ROADWAY & PAVEMENT MARKING PLAN
HANA HIGHWAY RESURFACING
Hookipa Park to Kaupakalua Road
Project No. 36BC-02-17M
Scale: 1" = 40' Date: December, 2016
SHEET No. 7 OF 19 SHEETS

HANA HIGHWAY RESURFACING
Hookipa Park to Kaupakalua Road
Project No. 36BC-02-17M

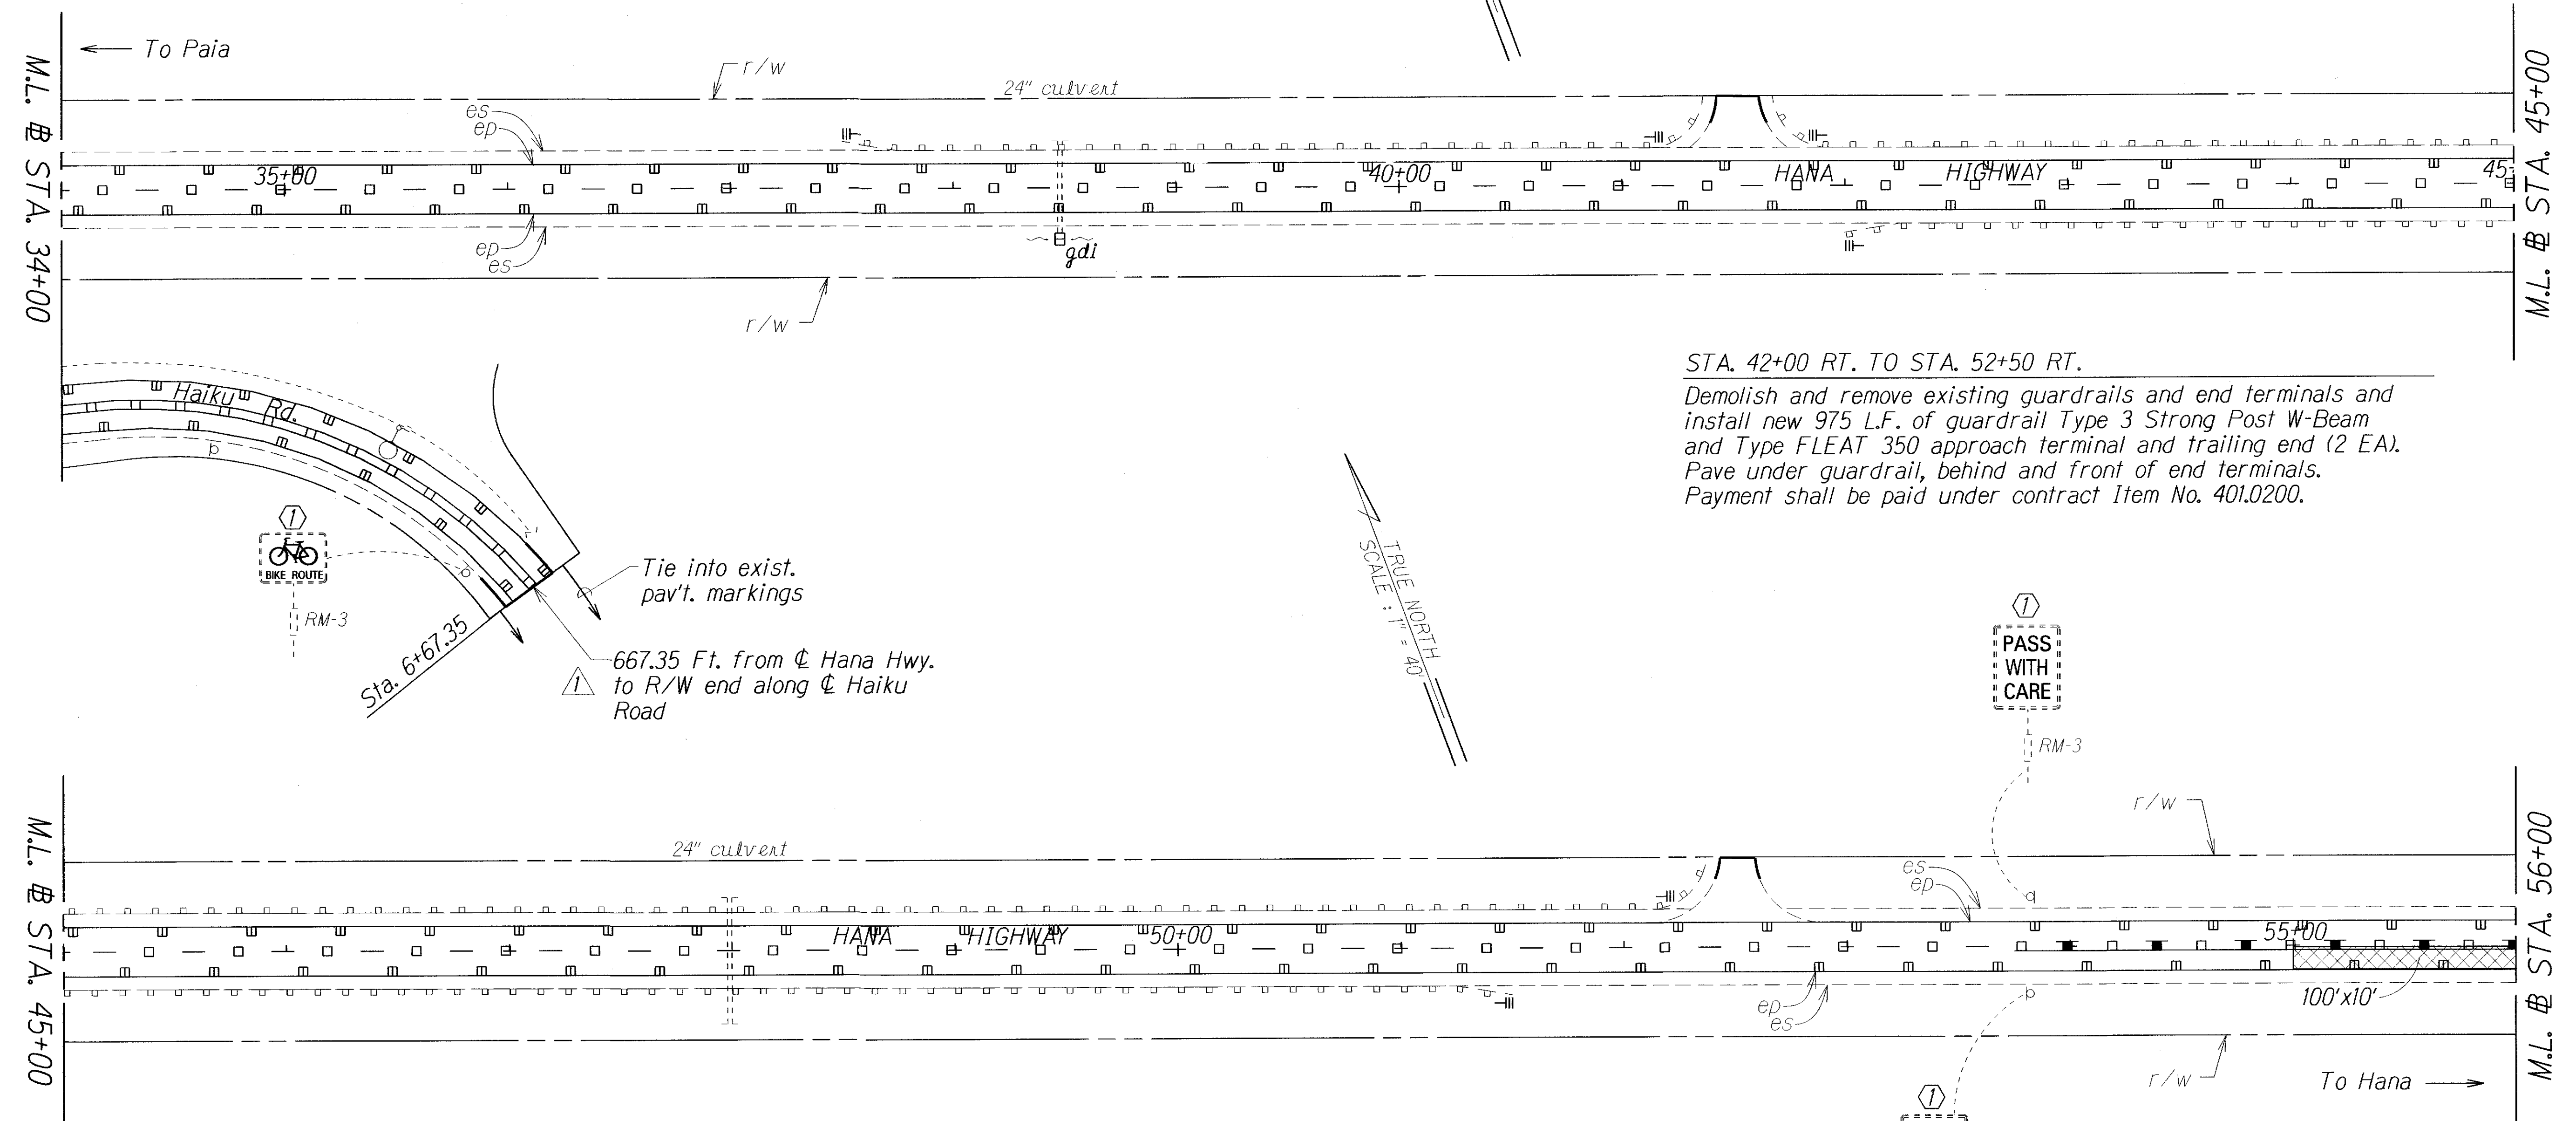
STA. 37+60 LT. TO STA. 37+22.5 LT.

Demolish and remove existing end terminal and install new end terminal Type FLEAT 350 (1 EA). Pave under guardrail, behind and front of end terminal. Payment shall be paid under contract Item No. 401.0200.

STA. 41+70 LT. TO STA. 52+40 LT.

Pave under guardrail, behind and front of end terminals. Payment shall be paid under contract Item No. 401.0200.

1	11-15-17	Station of Side Roads.
DATE	REVISION

FED. ROAD DIST. NO.	STATE	PROJ. NO.	FISCAL YEAR	SHEET NO.	TOTAL SHEETS
HAWAII	HAW.	36BC-02-17M	2018	ADD.32	42

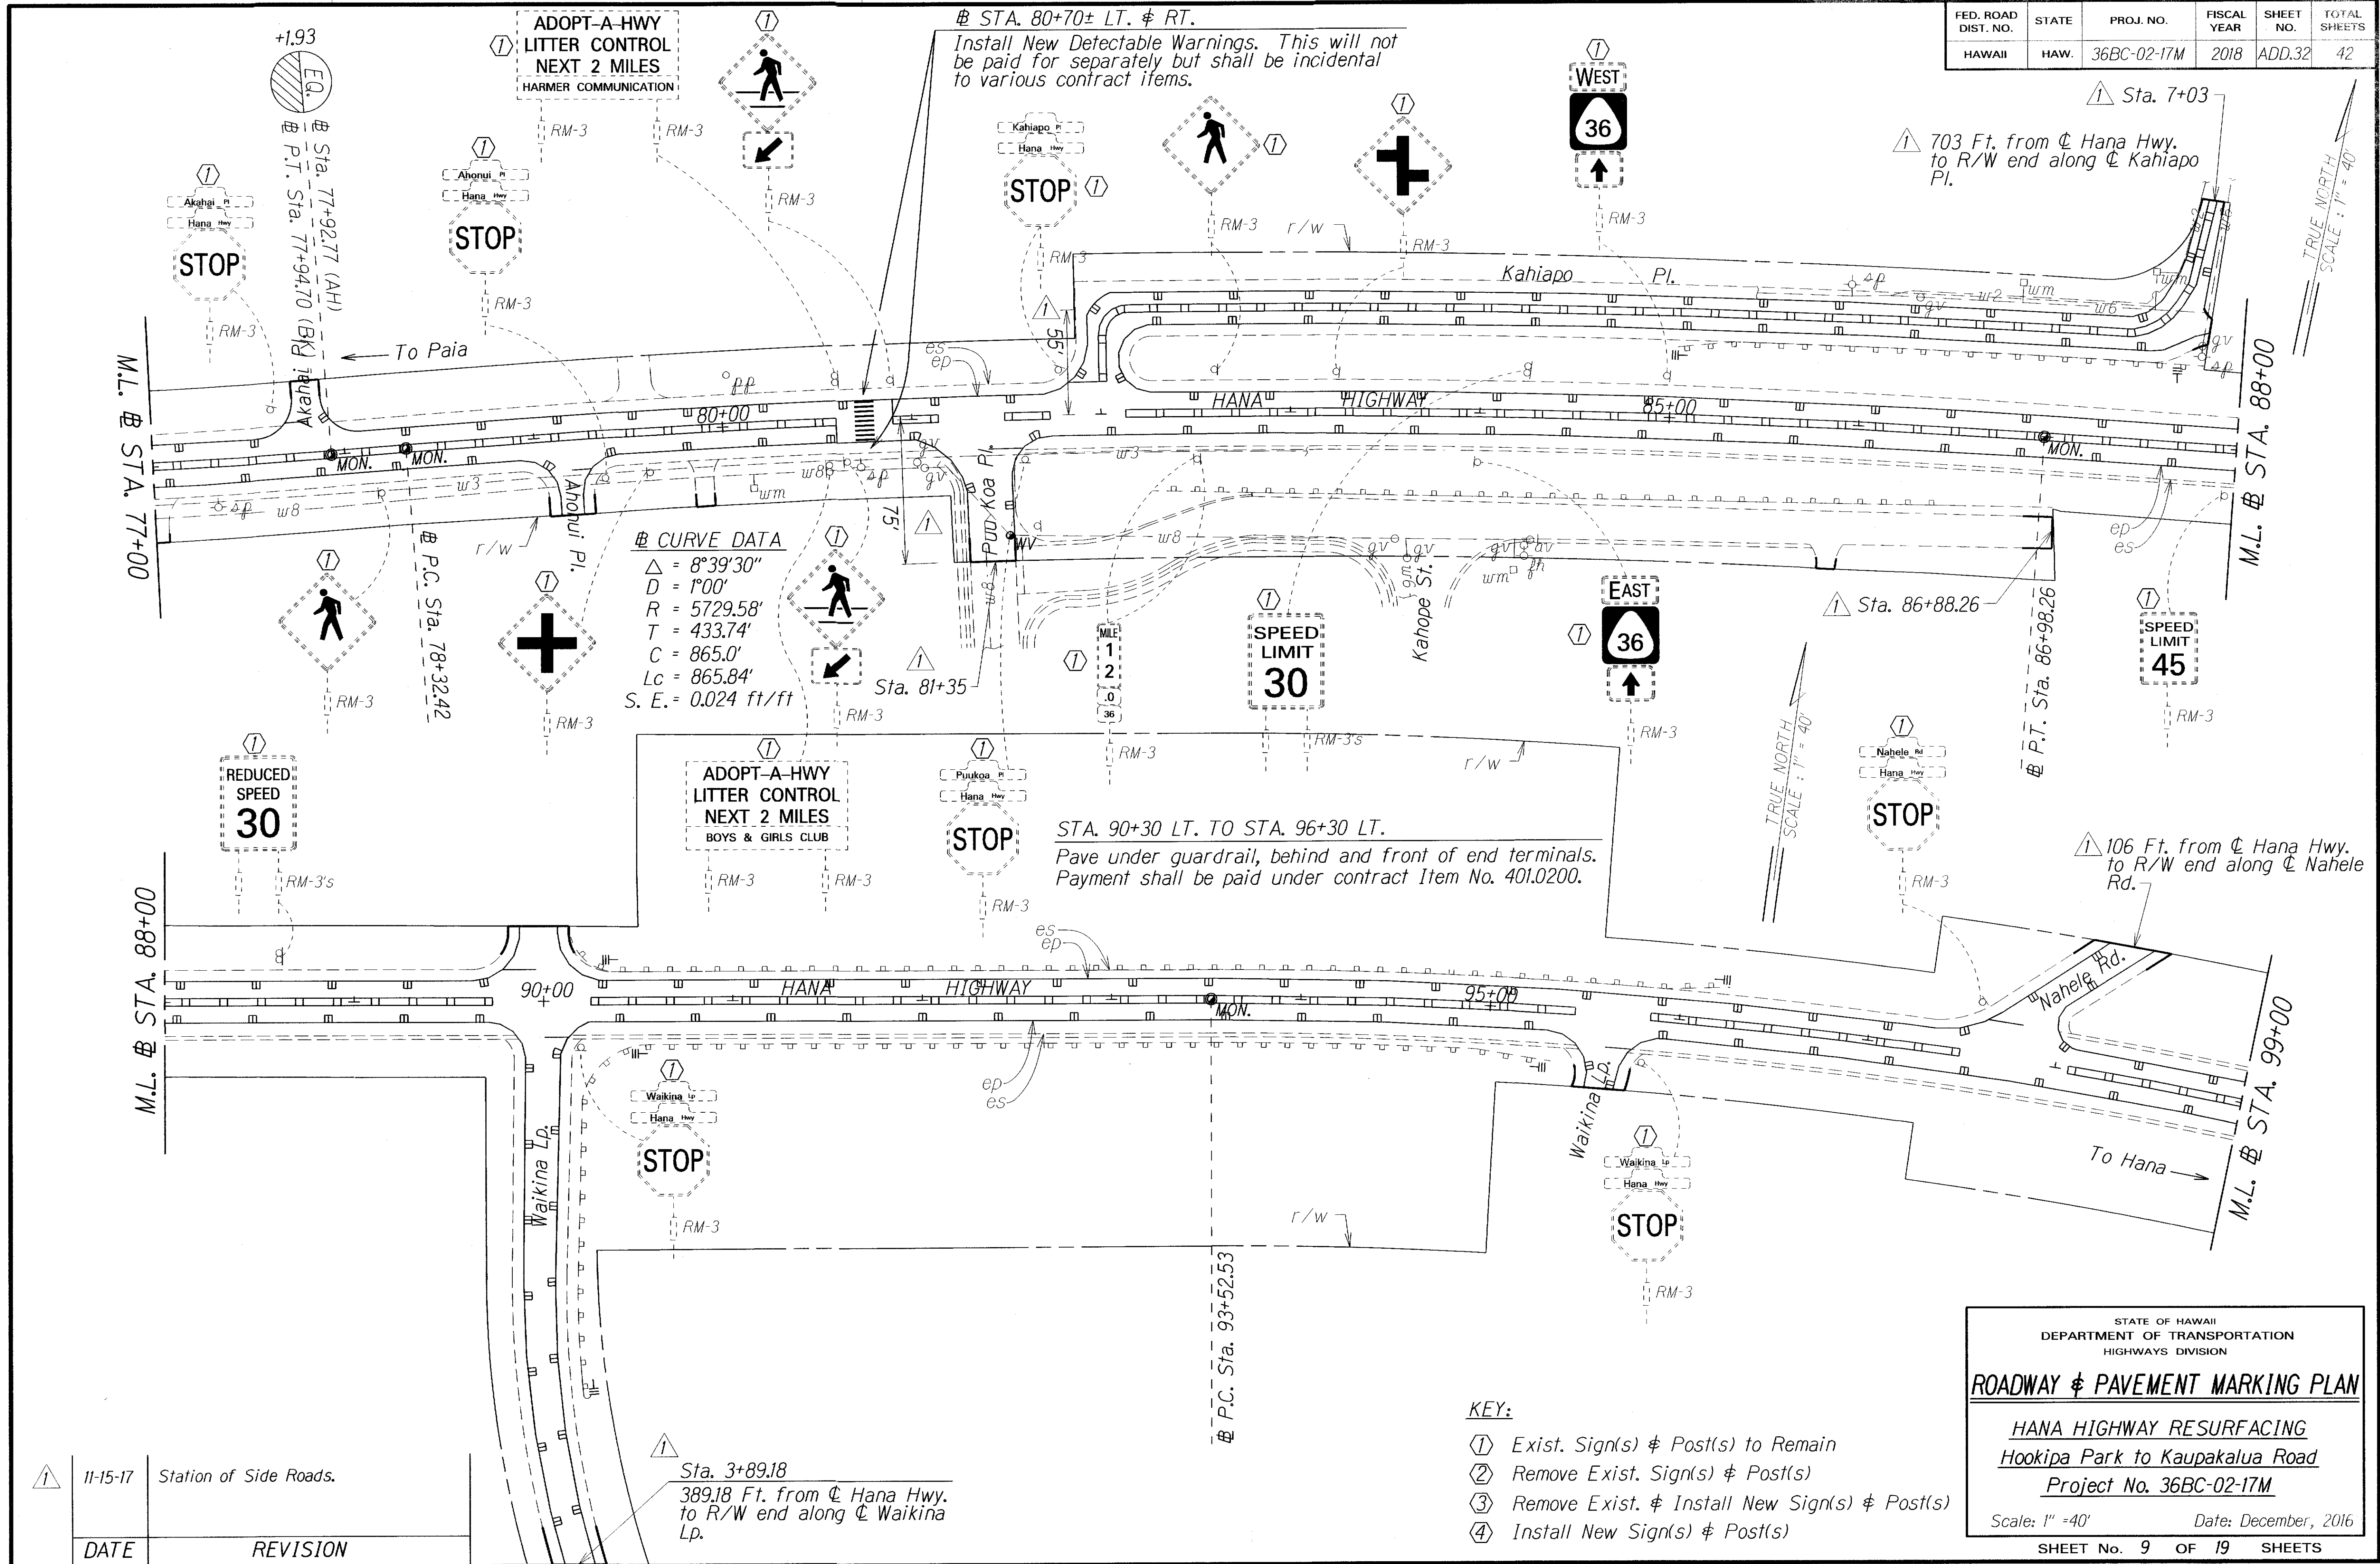
1	11-15-17	Station of Side Roads.
DATE	REVISION

SHEET No. 10 OF 19 SHEETS

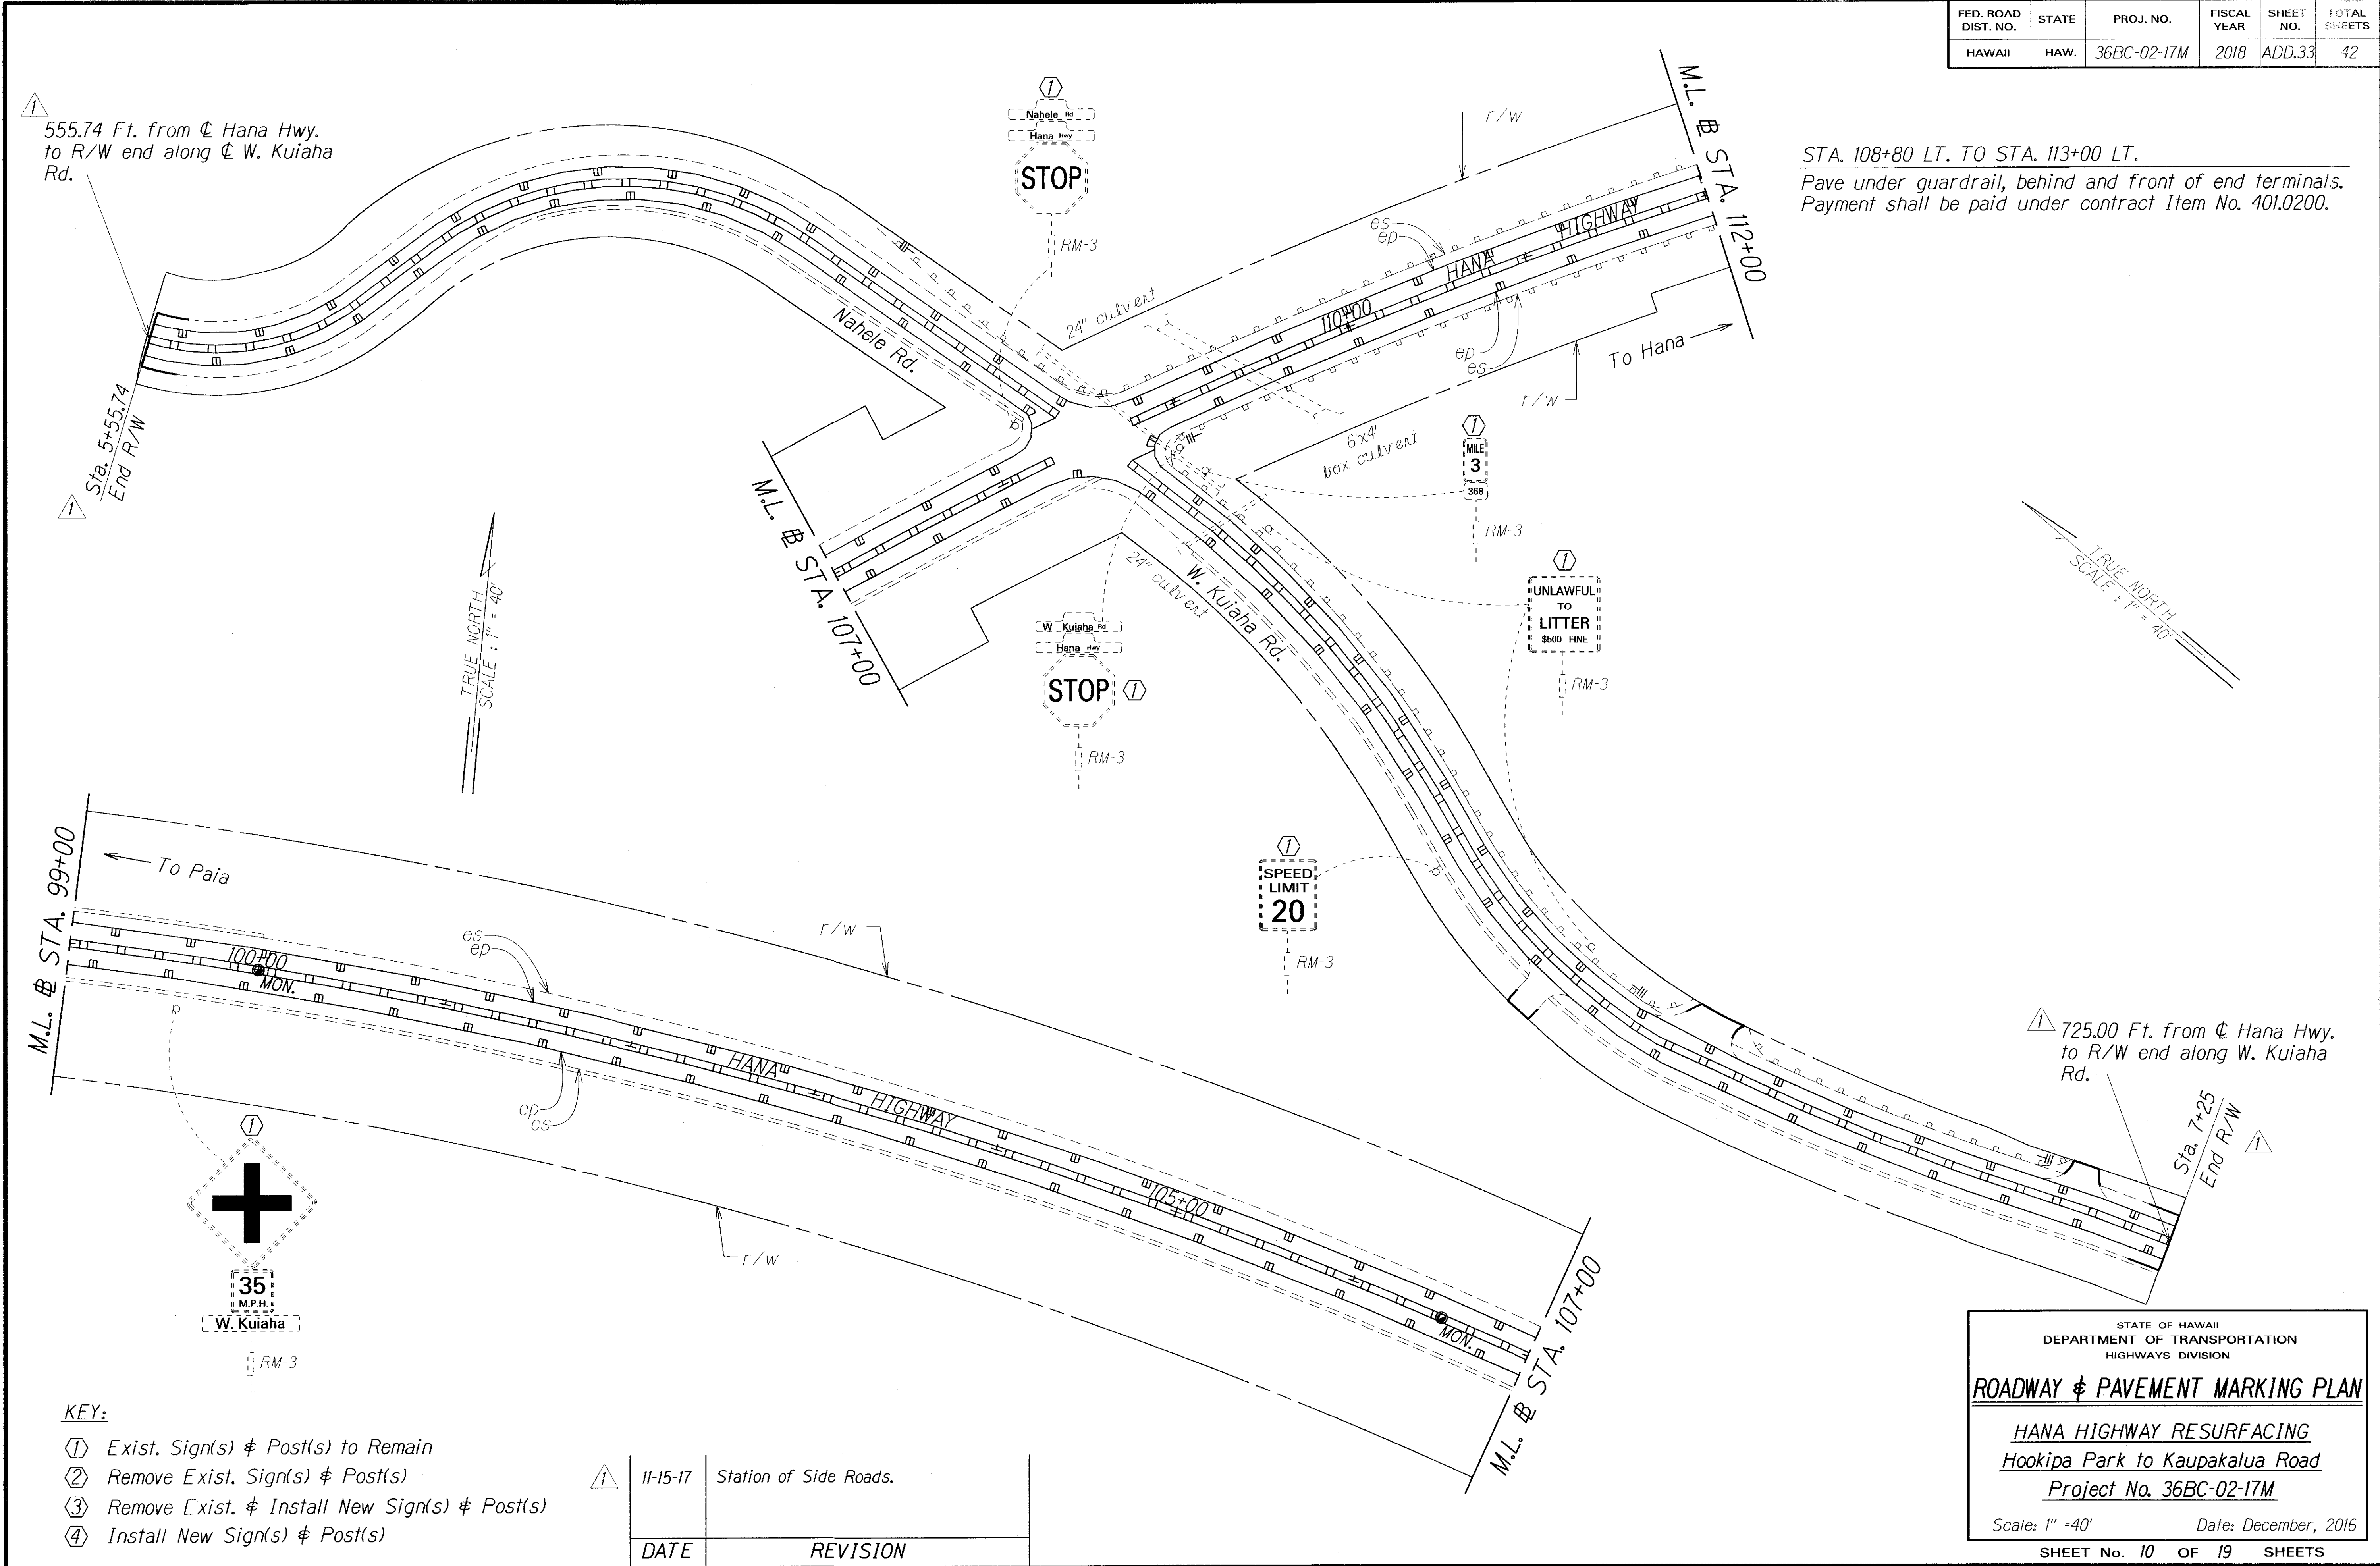
STA. 108+80 LT. TO STA. 113+00 LT.
Pave under guardrail, behind and front of end terminals.
Payment shall be paid under contract Item No. 401.0200.

①	11-15-17	Station of Side Roads.
DATE	REVISION
